UNITED STATES PATENT AND TRADEMARK OFFICE

APPLICATION NO.	FILING DATE	FIRST NAMED INVENTOR	ATTORNEY DOCKET NO.	CONFIRMATION NO.
10/501,817	01/27/2005	Ralf Salameh	710270-016	6860
59582 7590 02/01/2008 DICKINSON WRIGHT PLLC 38525 WOODWARD AVENUE SUITE 2000 BLOOMFIELD HILLS, MI 48304-2970			EXAMINER LEUNG, KA CHUN A	
			ART UNIT 3747	PAPER NUMBER
			MAIL DATE 02/01/2008	DELIVERY MODE PAPER

Office Action Summary

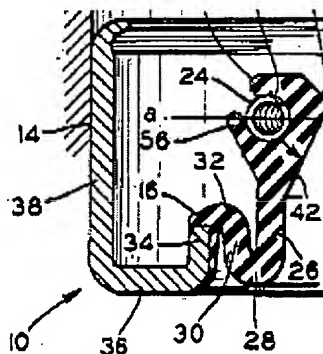
9. Specifically regarding Claim 17, the "radial sealing lip" defined by sealing lip (20) would inherently be "substantially radially aligned" with the carrier element especially when the shaft is in a neutral position or when no shaft is installed. Given the broadest reasonable interpretation, Figure 1 of Antonini et al could be considered as "substantially radially aligned" since the Specification does not distinctly disclose the range that it encompasses.

10. Specifically regarding Claim 18, the first reverse bend (28) and second reverse bend (32) extend generally in the horizontal direction in order to allow the sealing lip (20) to contact the shaft. The two bends form a wave shaped zone which "generally

extends coplanar" with the extending annulus since it extends "generally" in a horizontal direction as depicted in Figure 1.

17. In response to applicant's argument that ANTONINI et al does not disclose axial sealing lip, as discussed above in item 5, it is unclear whether the annular describes the carrier element or the fluid seal. As detailed in the previous Office Action in item 11, the flexible body portion (12) is "attached to the axially extending inside annulus (34) of the outer body (38)" (emphasis added). Note in particular that the inside annulus (34) extends upward axially away from the radial annulus (35). Alternatively, the portion of the seal directly adjacent and attached to the inside annulus (34) could also be considered as the "annular axial sealing lip". As shown below in a zoomed in view of Figure 1 from ANTONINI et al, seal adjacent to the inside annulus (34) extends axially and the bottom tip faces an axial direction of the opening. Furthermore, the thickness of this portion of the seal also extends outwardly away from both the inside annulus (34) and radial annulus (36).

18. In response to applicant's argument that the case (14) of ANTONINI et al is mounted in a cylindrical bore (40) and not "face mounted", a recitation of the intended use of the claimed invention must result in a structural difference between the claimed invention and the prior art in order to patentably distinguish the claimed invention from the prior art. If the prior art structure is capable of performing the intended use, then it meets the claim. Specifically, Claim 9 recites the bottom surface of the carrier element "to be positioned against a mating component". The structure provided by ANTONINI et al is capable of being placed against a mating component while still performing its intended function. For example if the bore contained a jutting wall or an end cap with a through hole, the bottom surface of the radial annulus (36) would be positioned against a mating component.
